SB-220
2 KW Linear Amplifier

Bulletin No:
SB-220-1

SBM-220-1 Modification Kit

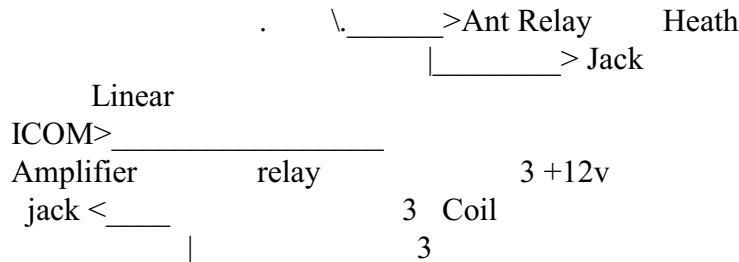
The 120 VDC at the Linear Amplifier antenna jack exceeds the 24 VDC maximum rating of the antenna relay contacts in the ICOM transmitter. This excess voltage causes the relay contacts in the ICOM transmitter to weld together. To prevent this, connect the ICOM transmitter to the Linear Amplifier using a 12 VDC as shown in the drawing below.

((Sorry for the poor drawing - just another reason to get the scanner working))

A relay box for this purpose is available for ICOM America, Inc.
